Subject: AP1000 Response to Request for Additional Information (SRP3.7.1)

Response to Request for Additional Information on SRP Section 3.7.1

AP1000 TECHNICAL REPORT REVIEW

RAI Response Number: RAI-SRP3.7.1-SEB1-02
Revision: 1

Figure 1.0-1: Comparison of the HRHF horizontal input spectra to the CSDRS

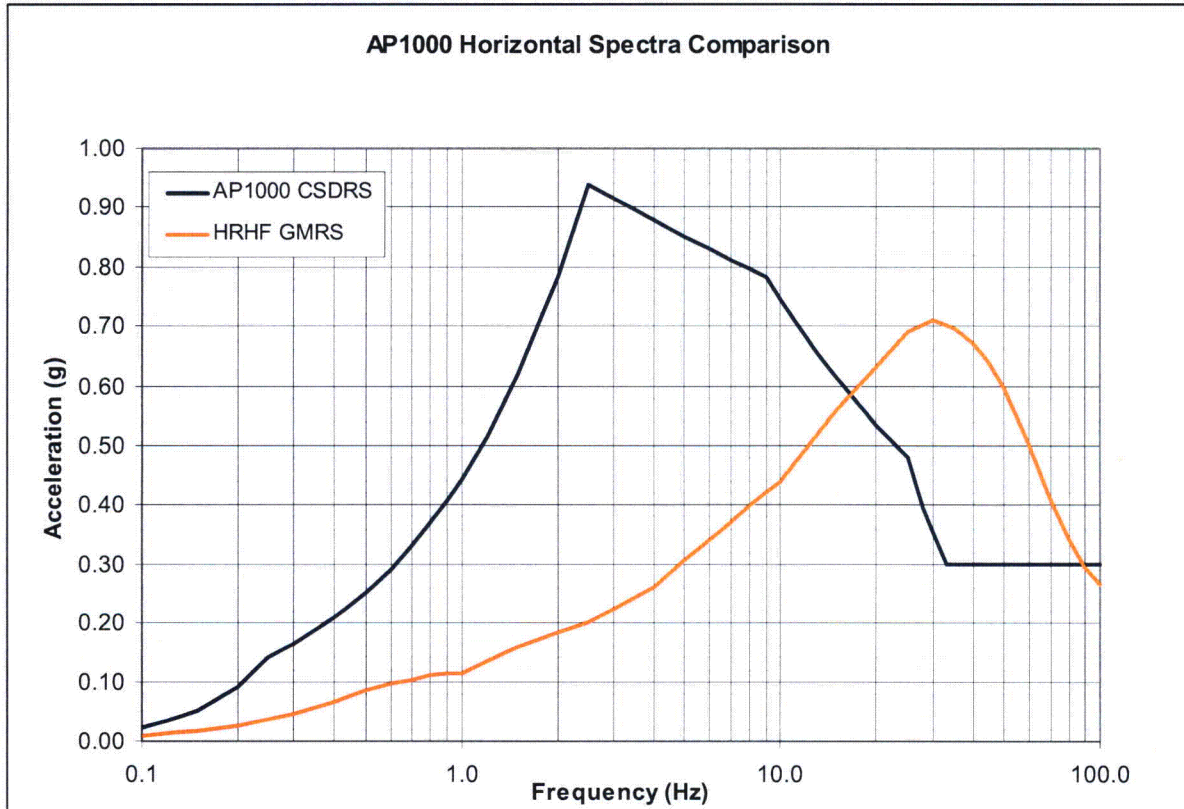
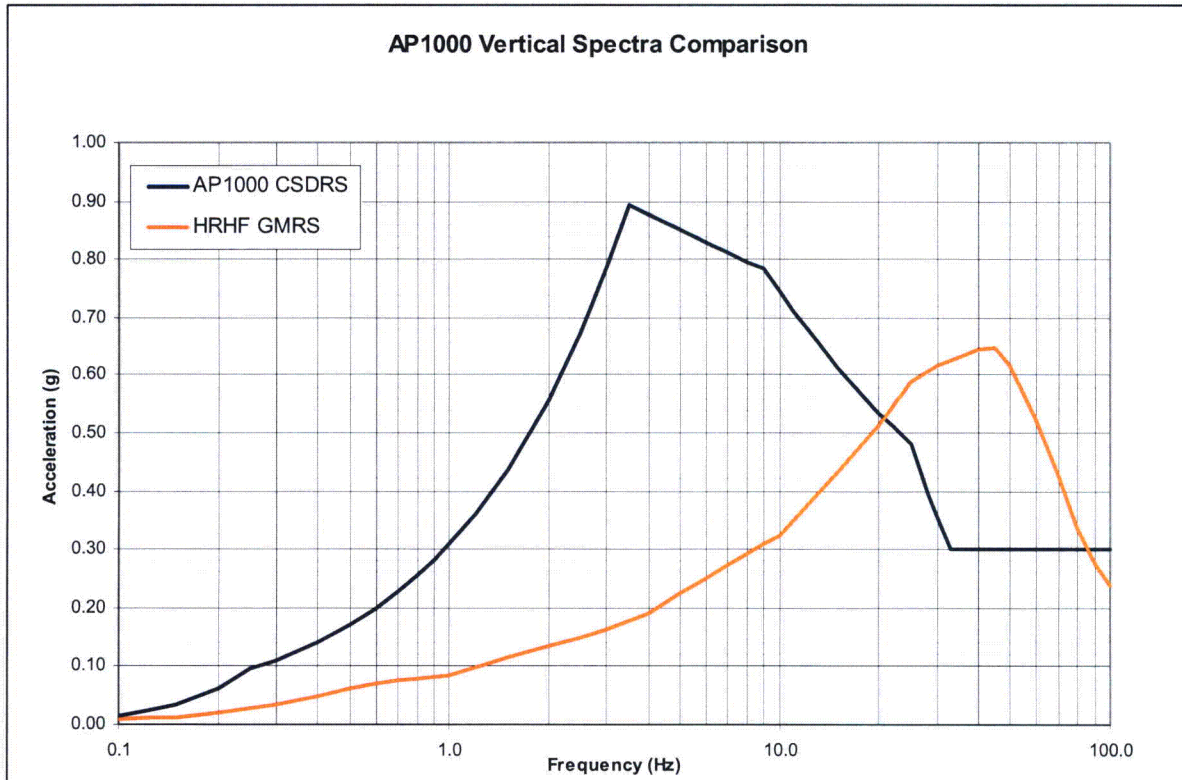
The purpose of the report is incorrectly stated, and may lead a reader to an incorrect conclusion. (1) and (2) above apply at best to the HRHFRS that Westinghouse has defined in this report (as further revised in TR-144), which supposedly envelope the 3 currently proposed CEUS hard rock sites. As stated above, a reader may reach the conclusion that Westinghouse’s two-fold purpose applies generically to “high frequency seismic input”. The staff requests that Westinghouse accurately state the purpose of TR-115.

This paragraph is also misleading, and may lead a reader to an incorrect conclusion. The staff requests that Westinghouse accurately state what has been specifically demonstrated in TR-115.

Modify Figures 1.0-1 and 1.0-2 to be consistent with Figures 5.0-3 and 5.0-4 given in TR-144.

Figure RAI-SRP3.7.1-SEB1-04-1 – X Seismic Response Spectra on Steel Containment Vessel at Elevation 224'

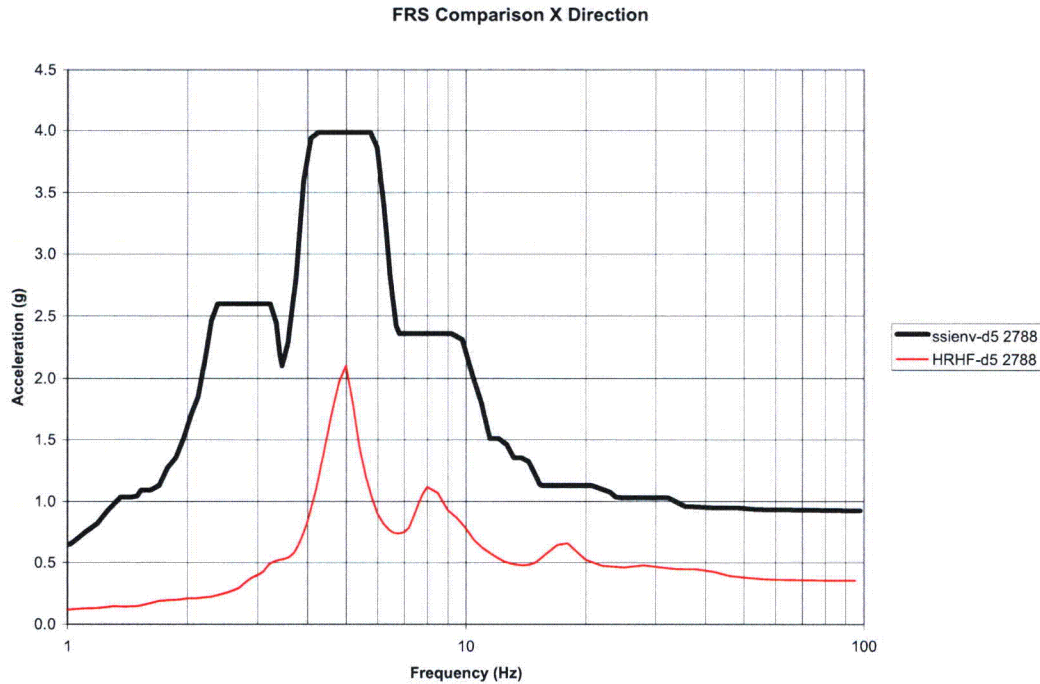
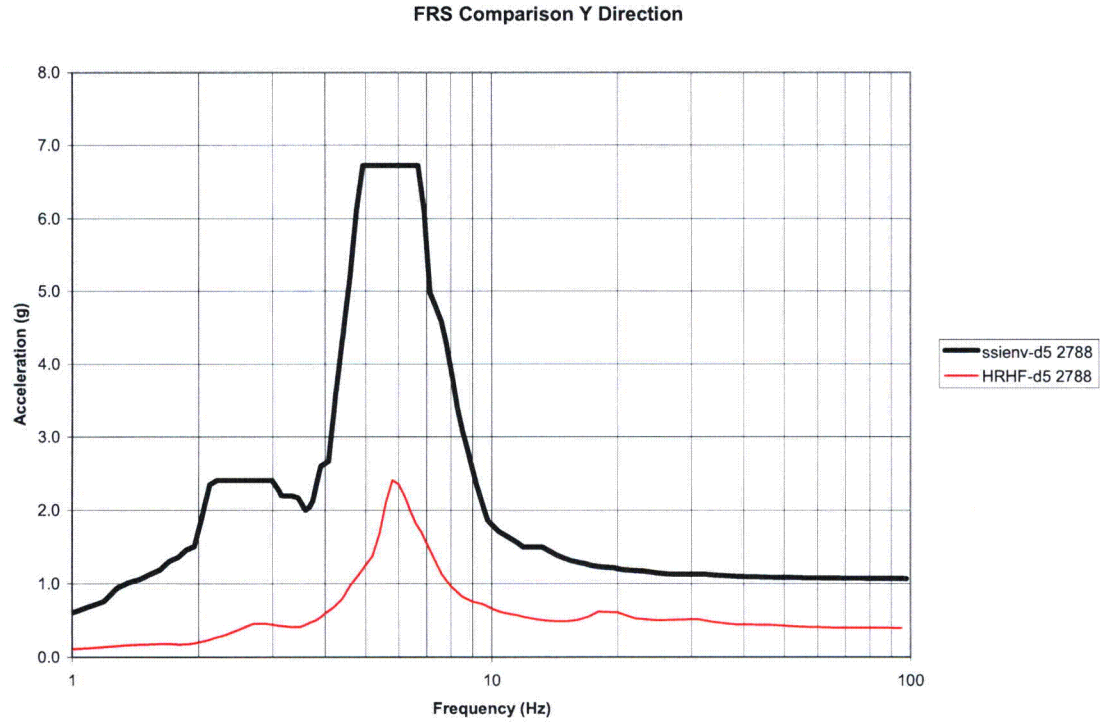
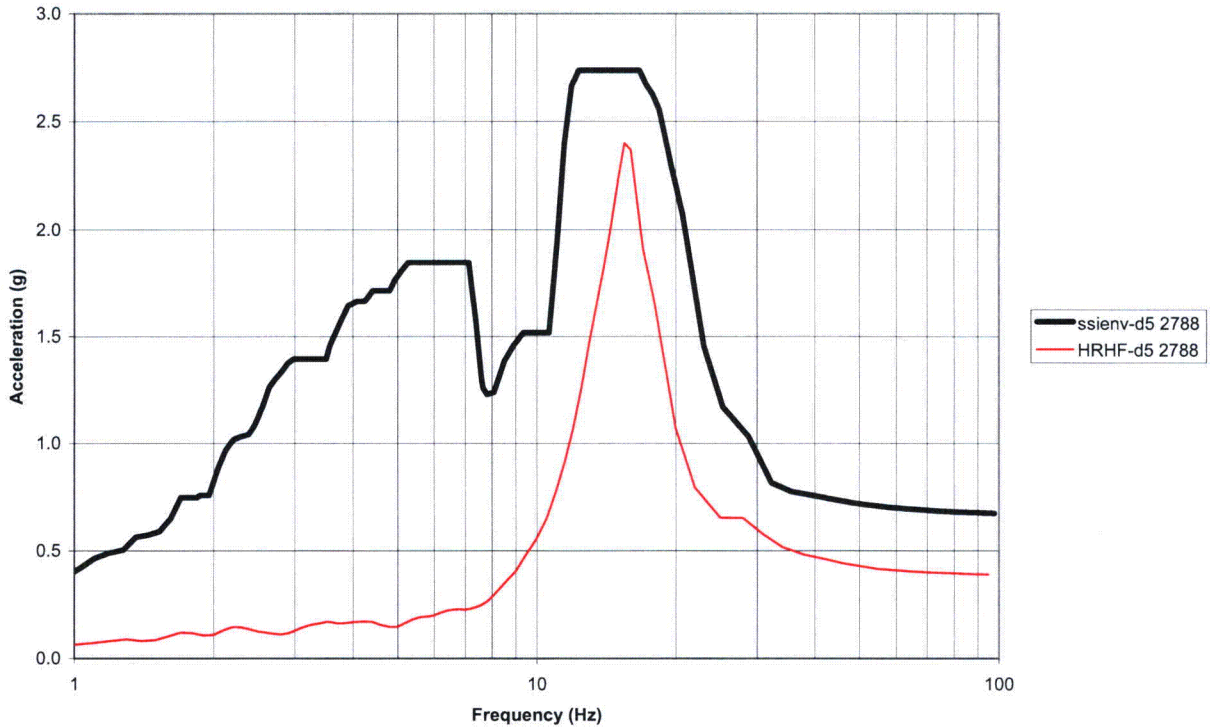
Therefore, the staff requests that Westinghouse expand its HRHF evaluation sample to include the Containment Structure, and also to specifically evaluate these high frequency modes, which are not represented in the AP1000 containment stick model.

The seismic response spectra in the vicinity of the polar crane (~224' elevation) is representative of the seismic response that the upper closure dome and the attached water weirs and air baffle attachments will experience. These floor response spectra (5% damping)

are shown in Figures RAI-SRP3.7.1-SEB1-04-1 to RAI-SRP3.7.1-SEB1-04-3. As seen from these spectra comparisons, the CSDRS floor response spectra identified as SSIENV envelop the HRHF floor response spectra. Therefore, it can be stated that the items identified (upper closure dome, water weirs and the air baffle attachments) will have lower response due to HRHF response than that obtained from the CSDRS excitation.

Figure RAI-SRP3.7.1-SEB1-06-1: X-Direction Comparison

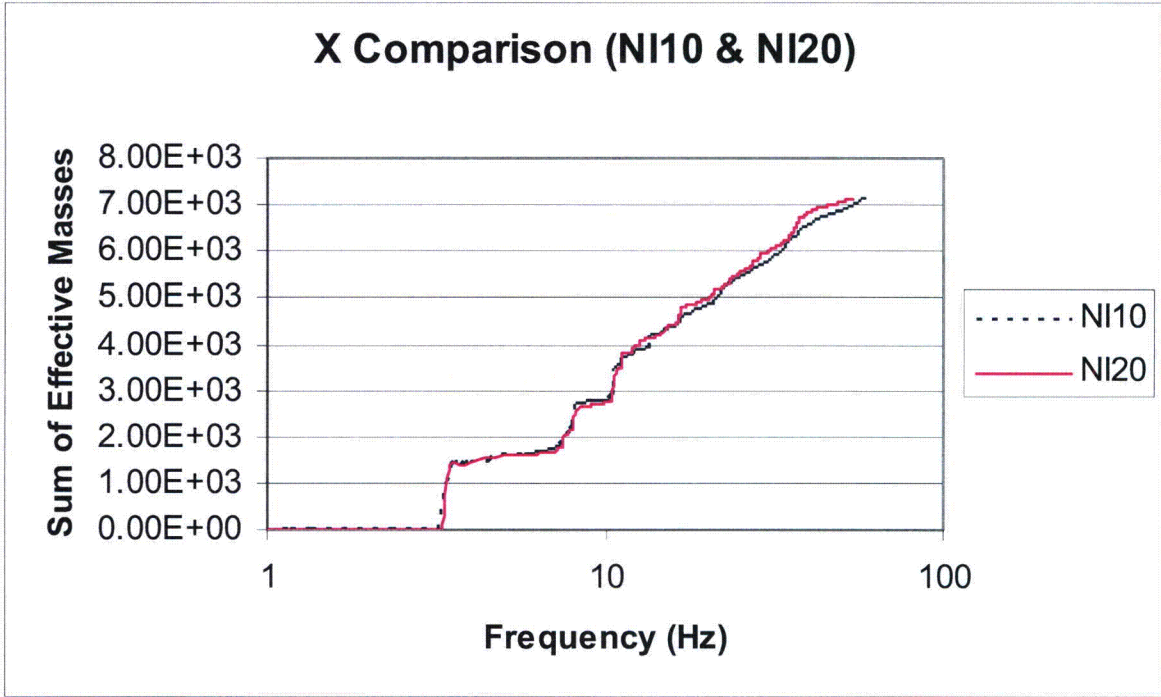
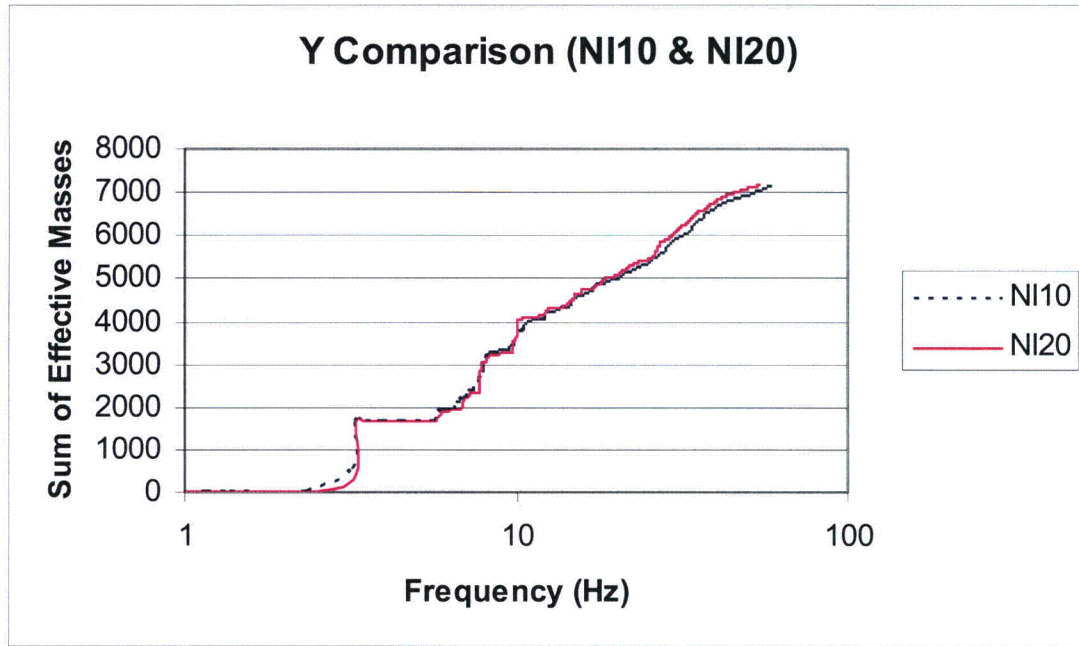
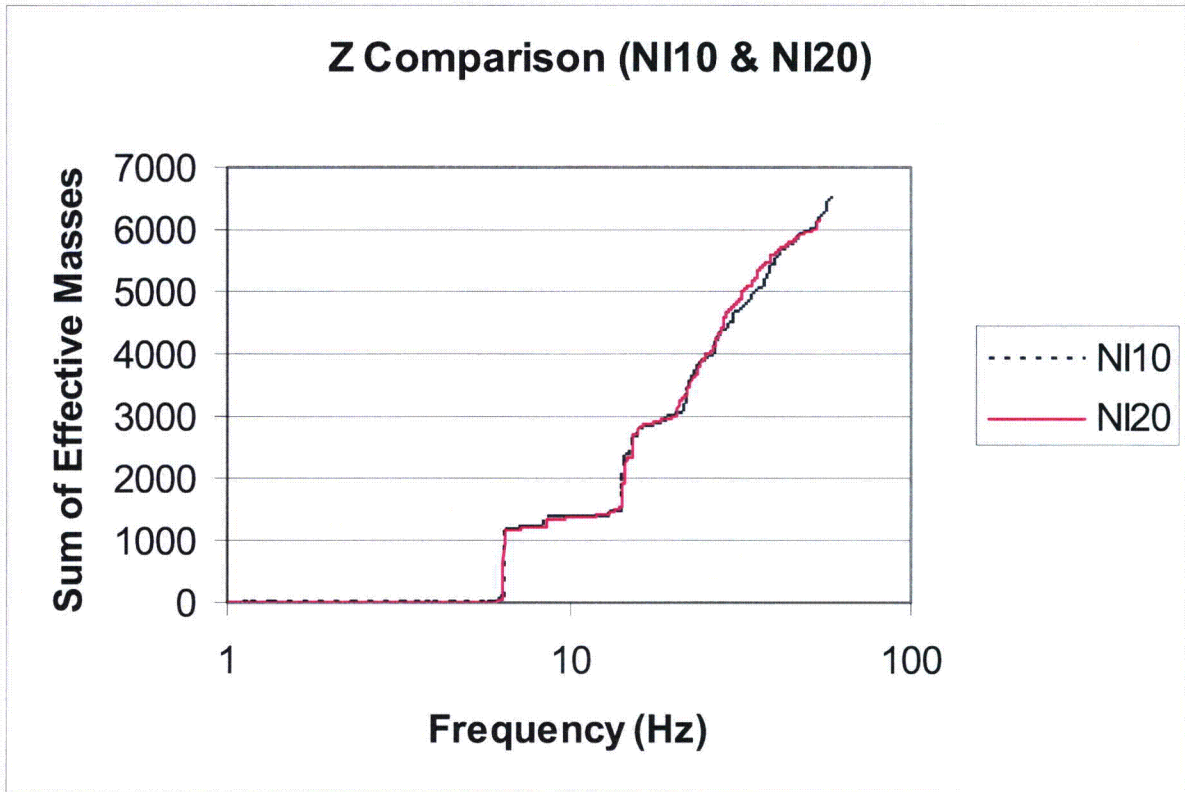
Westinghouse's calculation in TR-115 indicates 4 points per wavelength for 80 Hz. This is the bare minimum to represent a full cycle of sinusoidal displacement variation. The staff requests that Westinghouse include in Section 5.1 a comparison of frequencies and mode shapes between the NI10 and NI20 models, as an alternate way to demonstrate the adequacy of the NI20 model to accurately predict high frequency modes (up to 80 Hz).

Figures RAI-SRP3.7.1-SEB1-06-1 to RAI-SRP3.7.1-SEB1-06-3 show a summation of the of the effective mass verses frequency for the X, Y and Z directions. The effective masses associated with the NI20 and NI10 models compare closely over the frequency range of 1 to 80 Hz.

From this comparison it can be concluded that the modal response of the NI20 model is very similar to the NI10 model, and therefore, is adequate to predict the high frequency response up to 50 hertz.
